To: DRB, SB, UJFD, UCC
From: Sarah McShane, PZA
Date: 5/25/2015
Re: Agenda and Information for 6/1/15

Sketch Plan Review of the Application of Lamphere for a 2-lot Subdivision

Applicant(s): Luella Lamphere Estate (c/o Pat Lamphere)
Consultant(s): JH Stuart, P.E.
Property Location: 116 Beartown Road (BE116)
Acreage: ±10.0 Acres

SUBDIVISION SITE PLAN BEARTOWN ROAD (BE116)
UNDERHILL, VERMONT DUG. 1 OF 1 05/16/2015

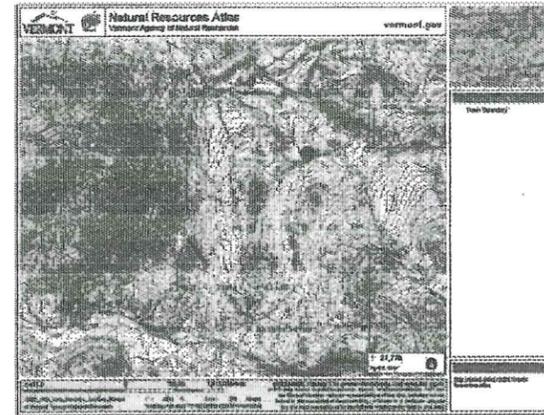
- The application materials state that Lot 2 is not proposed for immediate development. This should be discussed during the meeting.
 - See Section 3.2(D)(3 & 9)- Should the two driveways be redesigned to be shared? If so, the plans should be revised to indicate a shared driveway serving both lots and draft easement language should be provided as part of the preliminary/final application.

- Section 3.2(D)(9) states that “*Driveways shall be located not less than 12 feet from side and rear lot lines unless waived by the Development Review Board for shared driveways [see Subsection D.8 and Section 3.7(E)(3)] and lots with limited frontage [see Subsection B].*” As proposed, the driveway serving Lot 2 does not appear to meet this requirement.

- As proposed, the wastewater system for Lot 2 is located on Lot 3. Draft easement language should be provided as part of the preliminary/final application. A wastewater permit or permit application should be submitted as part of the preliminary/final application.

- Section 8.2(G) (page 146) requires the designation of building envelopes to “limit the location of structures, parking areas, and associated site improvements to one or more portions of a lot.” Building envelopes should be indicated for both lots.

*Is this a designated
building envelope?*

*2 proposed
driveways*

*Is this the
proposed interior
lot line?*
